INDUCTION HOB – Replacement KingLeopard 3-zone Induction board

How to handle the KingLeopard 3-Zone Induction board while it must be exchanged for service

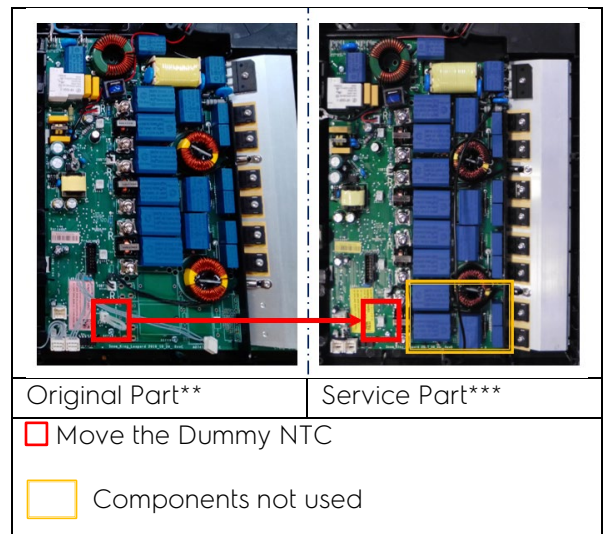
On appliances where the front generator* is not used the board is only populated with the components for the 3 generators.

In the service case this board will be replaced by the full populated induction board. The dummy NTCs must be moved from the exchanged board to the service part. There are no additional parts needed.

- Fix all screws for the coils, even when not used.
- Do not use additional parts like Jumper or Dummy NTC.
- Take all parts from original board and move to spare part.
- No difference in Software between 3 and 4 generator version.
